NRC Bulletin 2003-02
Leakage From Reactor Pressure Vessel Lower Head Penetrations
And Reactor Coolant Pressure Boundary Integrity

Turkey Point Plant Units 3 and 4 Response NRC Bulletin 2003-02

NRC BULLETIN 2003-02: "LEAKAGE FROM REACTOR PRESSURE VESSEL LOWER HEAD PENETRATIONS AND REACTOR COOLANT PRESSURE BOUNDARY INTEGRITY," RESPONSE FOR TURKEY POINT UNITS 3 AND 4

Figure 1: Turkey Point Unit 3 BMI penetration # 35 at the vessel interface during 2003 RFO. Note clean insulation surrounding the penetration and no boron deposits or accumulation.

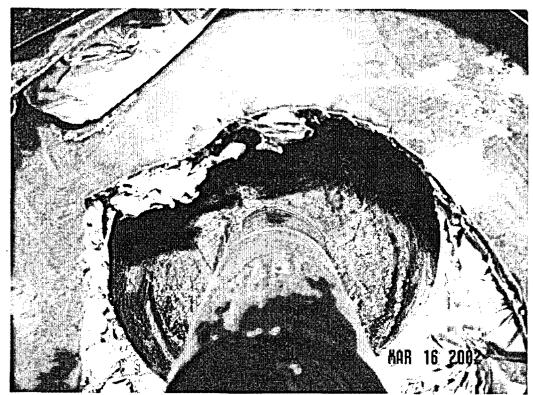
NRC Request 1(a): A description of the RPV lower head penetration inspection program that has been implemented at your plant. The description should include when the inspections were performed, the extent of the inspections with respect to the areas and penetrations inspected, inspection methods used, the process used to resolve the source of findings of any boric acid deposits, the quality of the documentation of the inspections (e.g., written report, video record, photographs), and the basis for concluding that your plant satisfies applicable regulatory requirements related to the integrity of the RPV lower head penetrations.

During the Turkey Point Unit 3 spring 2003 RFO, the leak inspection walkdown of the BMIs revealed a minor discoloration on BMI # 35. A condition report was written as required by our corrective action program. As part of the disposition, insulation cover plates were removed around BMI penetration # 35 to reveal the interface where the nozzle enters the reactor vessel lower head. A direct visual examination was performed by a qualified VT-2 examiner and documented as part of the corrective action program. Digital images of the examination area were also recorded as shown in the figure below. The stain on both the nozzle and the RV surface was described as a dry rust film of no discernible thickness. The stain trail was observed coming from above this outer periphery nozzle (#35) on the vessel surface. No white boron deposits or accumulation was noted on the vessel surface or around the circumference of the nozzle as it penetrated the RV surface (see figure below). The source of the rust stain on the RV lower head surface and BMI penetration #35 was determined to be coming from above, most likely cavity seal ring leakage during refueling and not relevant as a BMI leak since there is no heat source to concentrate boric acid. Similar staining was also noted on the RV cavity walls below the refueling cavity seal ring. A smear sample was taken of the rust stain to analyze the activation products to determine the age of the stain/leak source. However, due to the stain having no discernable thickness (small sample size) the results were inconclusive.

FPL Response to Request 1(a): As identified in the response to Question 5 ¹ of the NRC request for additional information on boric acid inspection programs, previous inspections of the bottom mounted instrumentation penetrations (BMIs) at Turkey Point Units 3 and 4 have been performed as part of the ASME Section XI system leakage test walkdown performed at every (18 month) refueling outage (RFO) with the system at normal operating pressure and the insulation in place. These walkdown inspections are performed by procedure and documented on a system pressure test report in accordance with our ASME Section XI program. Although past procedures did not specifically identify the BMI nozzles, the system

pressure tests and boric acid program walkdowns have never identified any BMI leakage. However, minor discoloration was noted at the last Turkey Point Unit 3 RFO that was dispositioned as cavity seal ring leakage as discussed below:
